UZBEKISTAN GAS TO LIQUID PROJECT (UZGTL)

HAZOP ACTION CLOSE-OUT REGISTER FOR MAKE-UP H2 COMPRESSOR PACKAGE

UZGTL-HDC-HSE-RP-50-0-0004

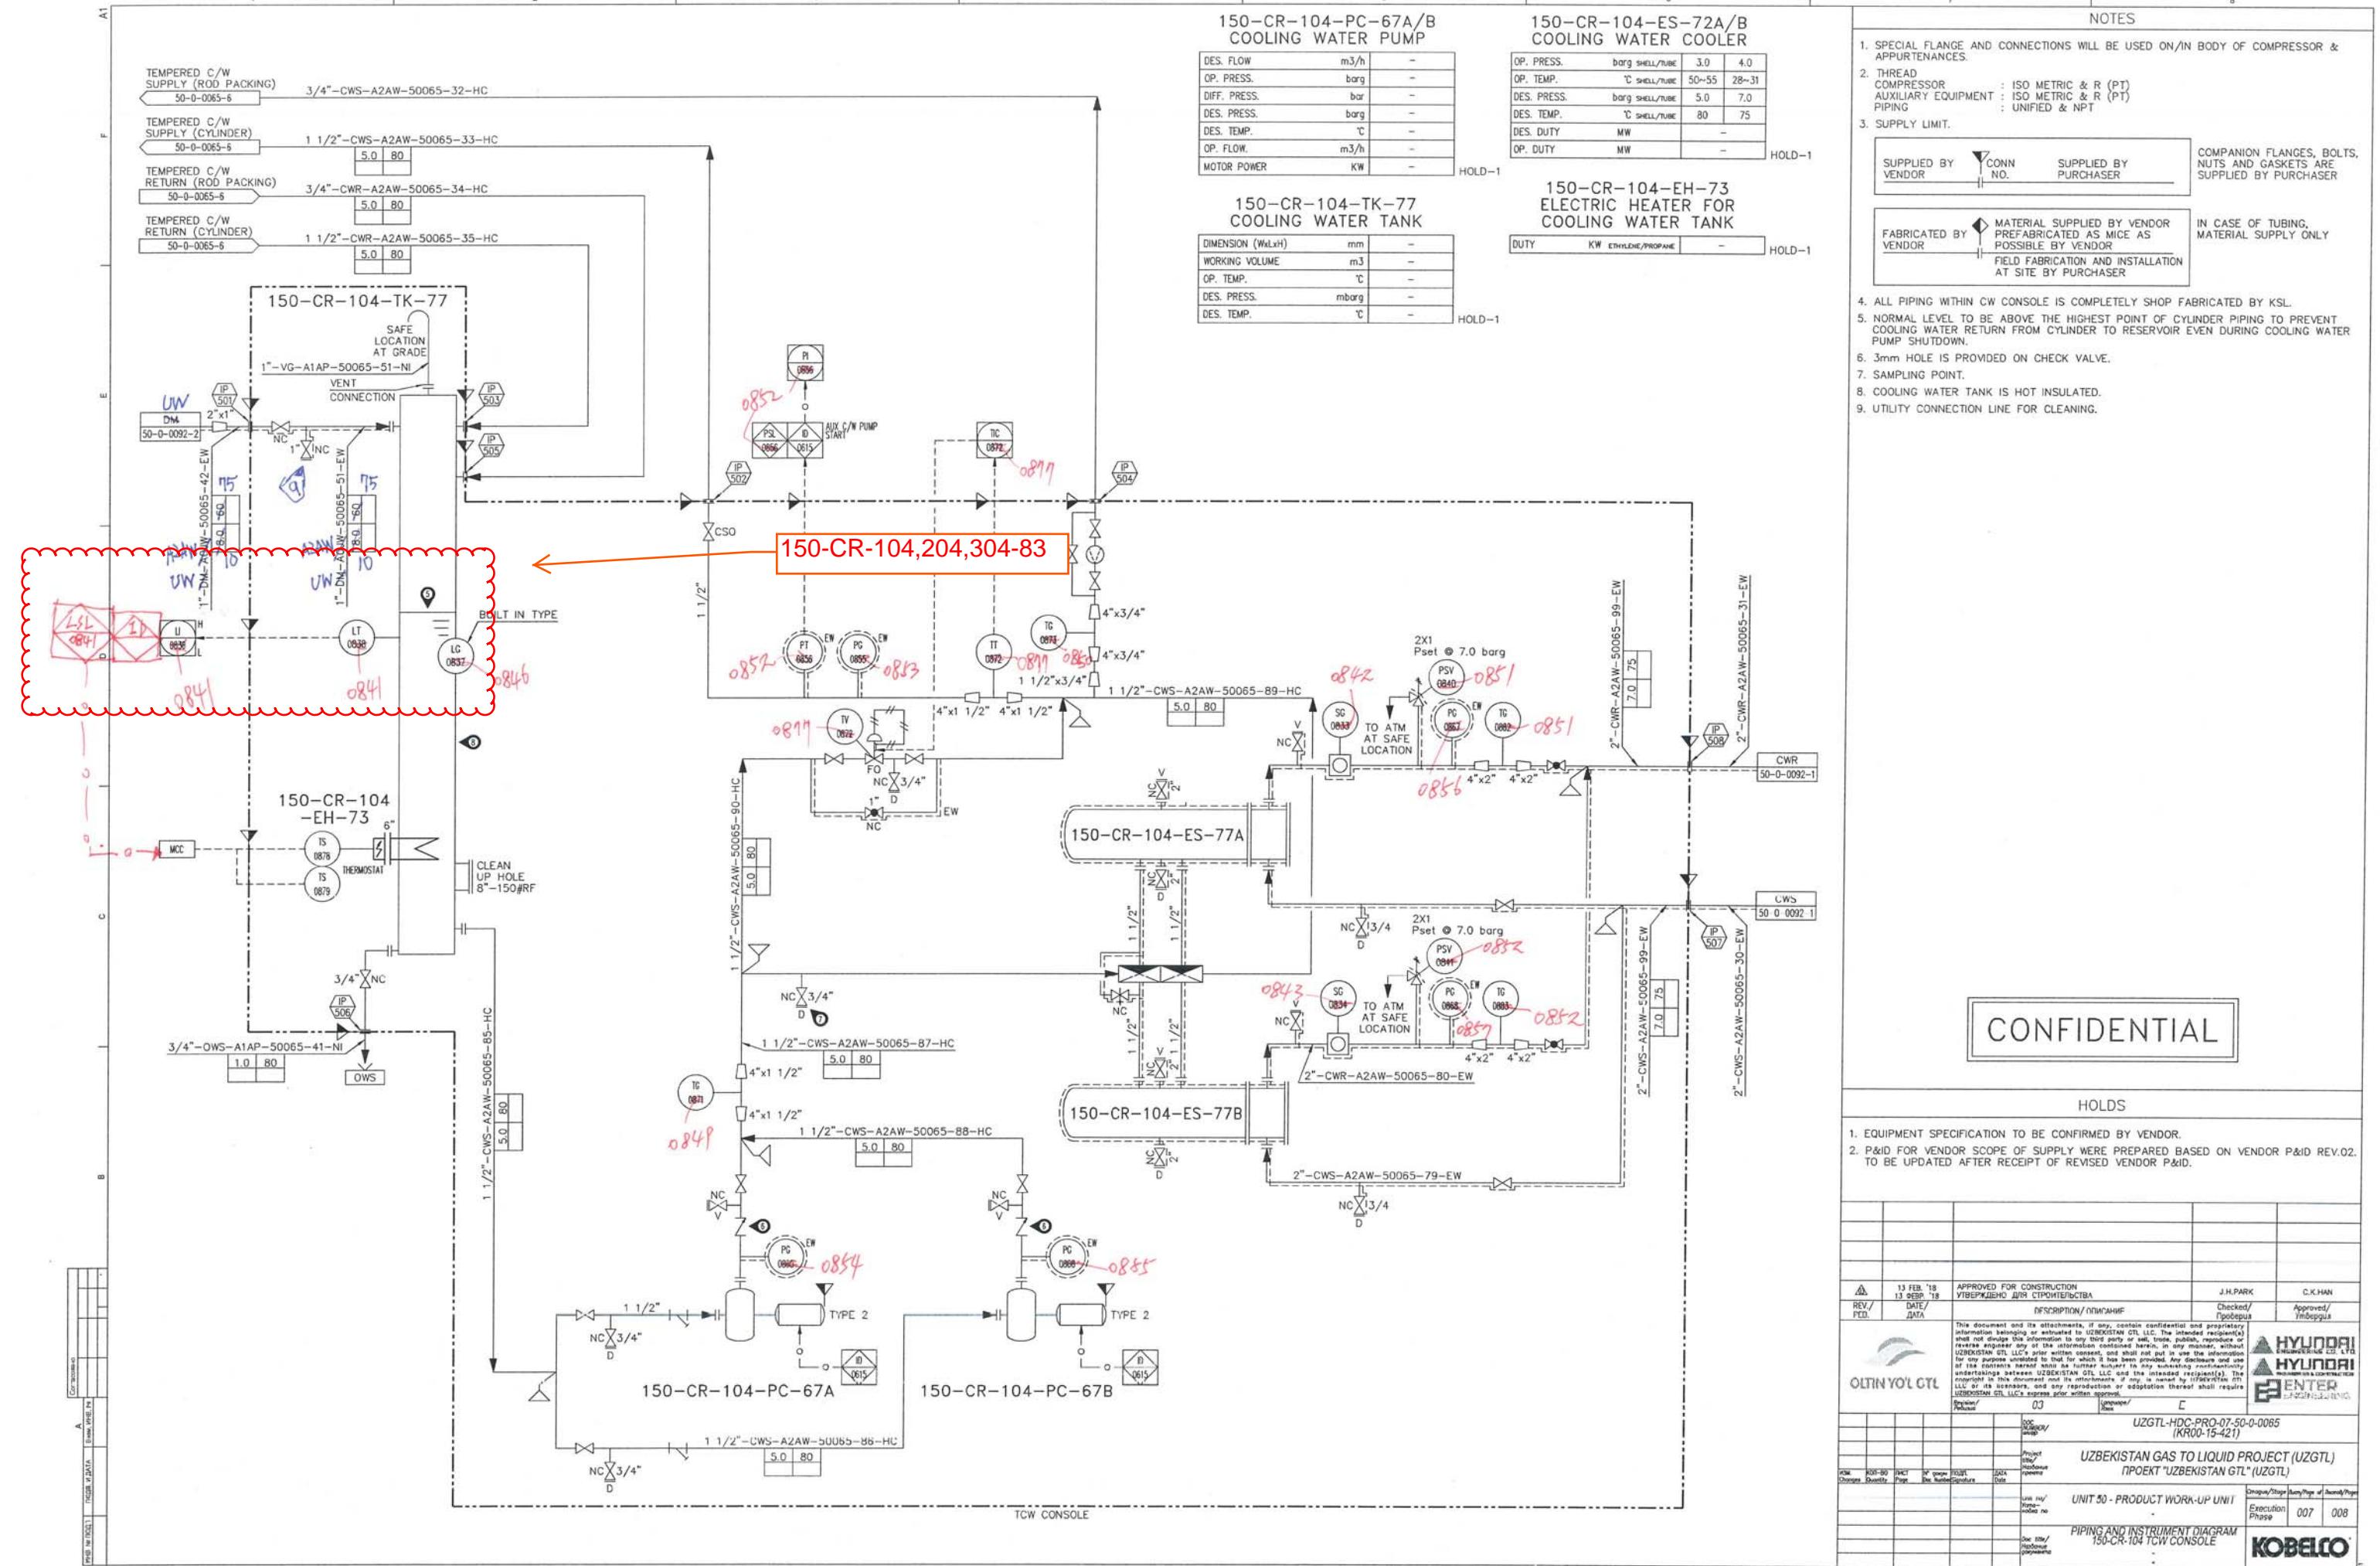
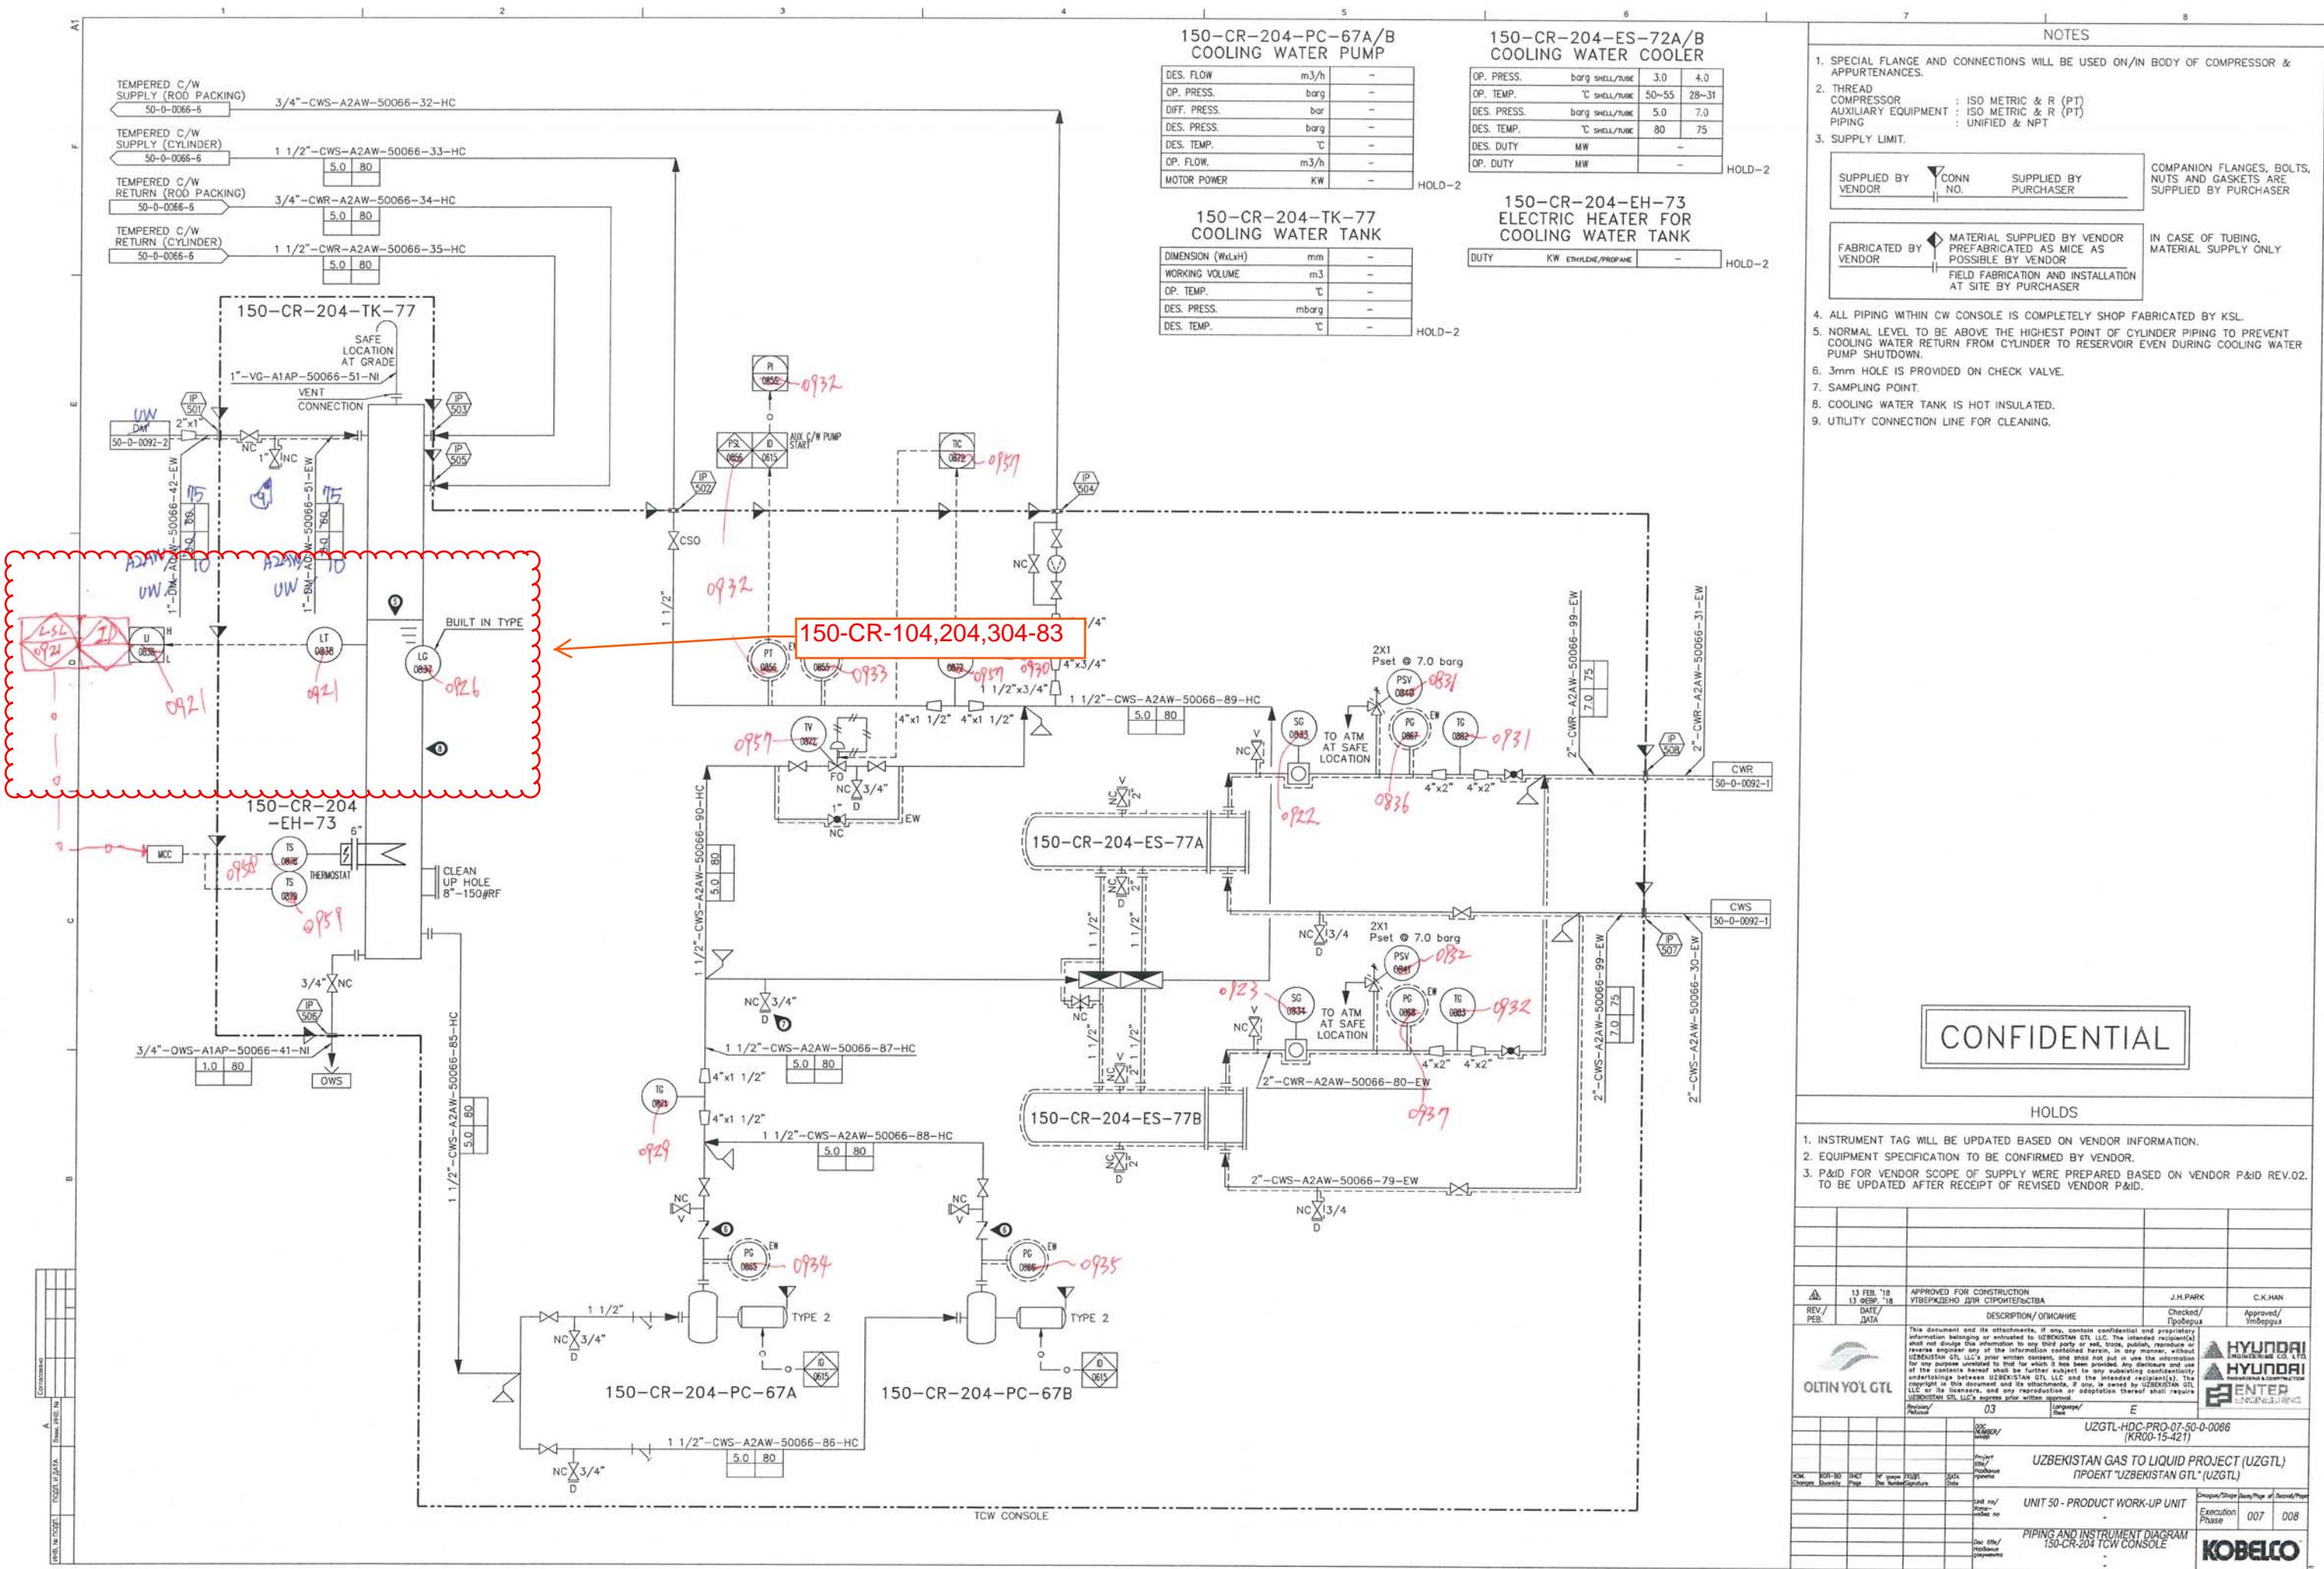
Action No.	150-CR-104/204/304-83				
Action By	PR				
Node No.	3				
Node Description	3. Cooling Water / TCW console				
Cause	3.5.1. Cooling Water Cooler tube rupture 3.10.1. Cooling Water Tank overfilling due to incorrect refilling				
Consequence	3.5.1.1. Cooling water flow from tube side to shell side leading to overfilling of Cooling Water Tank. Potential fouling of cooling jackets. 3.10.1.1. Loss of cooling water. No significant issue.				
Safeguards	3.5.1.1.1. Vent routed at grade level acting as overflow line (Refer to Recommendation) 3.10.1.1.1. Vent routed at grade level acting as overflow line (Refer to Recommendation)				
Action	Configure 150-LAH-0838A on DCS

Response	Incorporated on P&ID (50-0-0065/66/67-7). 150-LAH-0838A on DCS is provided on AFC P&ID. (Please refer to attached P&ID, UZGTL-HDC-PRO-07-50-0-0065/66/67-7)				
CONTRACTOR			OWNER		
Position	Signature	Date	Position	Signature	Date
Process Engineer	<u>B.M.Hwang</u> 	10-Apr-2018		_____
